RUNE PROJECT CALL

REQUEST FOR FINAL OFFER for the supply and integration of active network layer systems

Questions and answers V2_27112019

Since the fiber optic cable network topology is not clear, you are kindly asked to precise which of the following **physical connectivity** diagrams are required for the DWDM network:

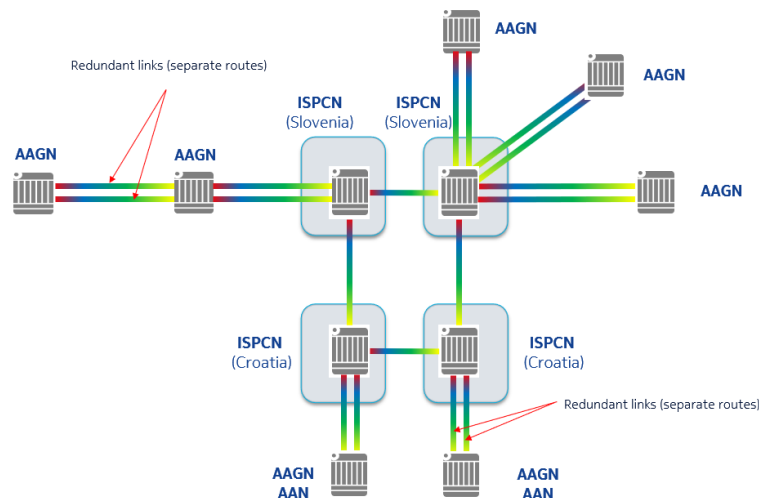
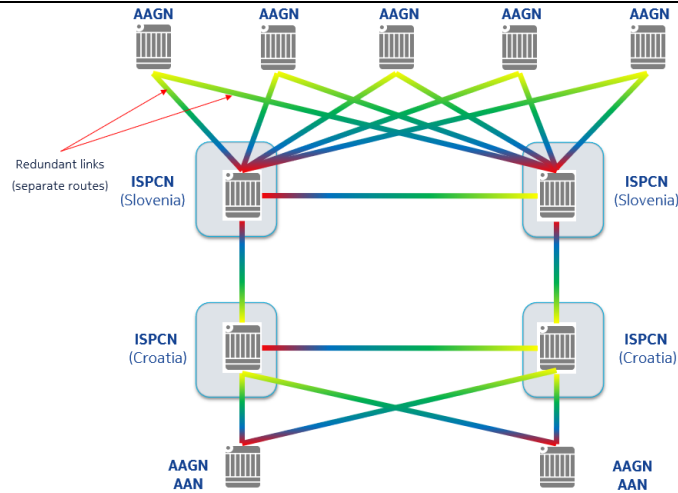
- a. in page 3 is mentioned: five AGGN nodes in Slovenia with multiple AGGN devices, which must have redundant connection to both ISPCN nodes in Slovenia.
- b. in page 7 chapter 1.2 is mentioned that “Connection between ISPCN and each AGGN node is done via two geographically independent fiber connections”.
- c. in page 10, chapter 1.5 it is mentioned that “Each AGGN device must be connected to all ISPCN locations in region”.

Option 2.

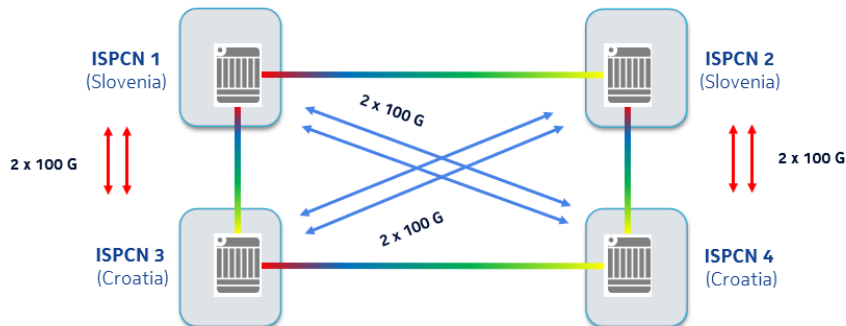
Can you please precise the distance between the two ISPCN locations in Croatia?

67 km, Matulji-Pazin.
